Technical BULLETIN

SAFETY RECALL

2011 FJR13AAS/AASC MODELS FACTORY MODIFICATION CAMPAIGN – Front Brake Switch

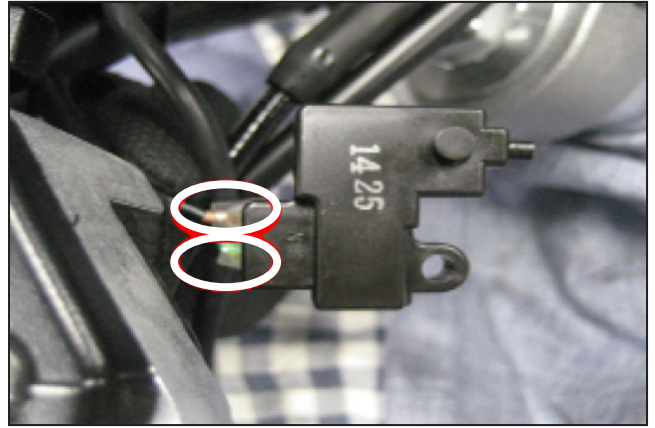
1. Remove the screw holding the front stop switch assembly. Keep the screw for reuse.

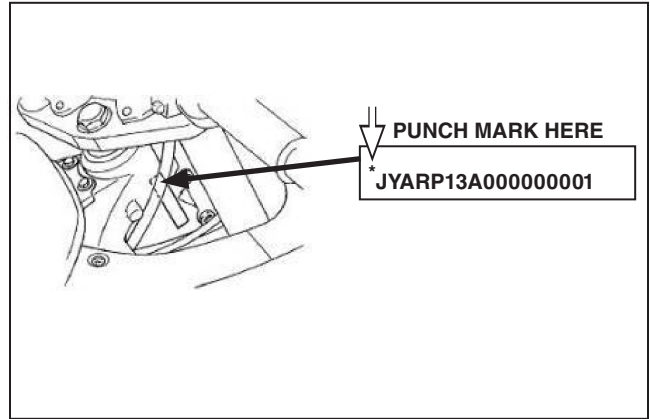
5. Install the front stop switch on front master cylinder, with the projection on front stop fitting into the corresponding hole in the master cylinder.

6. Reinstall and tighten the mounting screw.

|  | <p>Tightening Torque 0.8~1.5 Nm (0.08~0.15m-kg, 0.6~1.1 ft-lb)</p> |

Part Identification

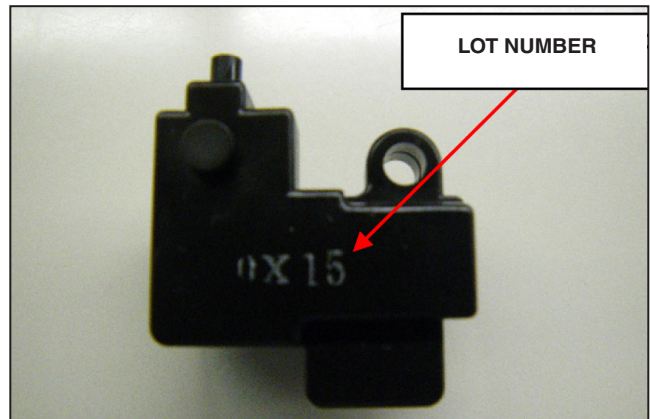
The lot numbers of defective parts are “0X15” through “1419.” The lot numbers are a date code as follows:

Therefore, the 0X15 example shown in the photo is October 15th, 2010, production (needs replacement). The lot numbers of corrected parts begin with “1420,” which is April 20, 2011 or later.
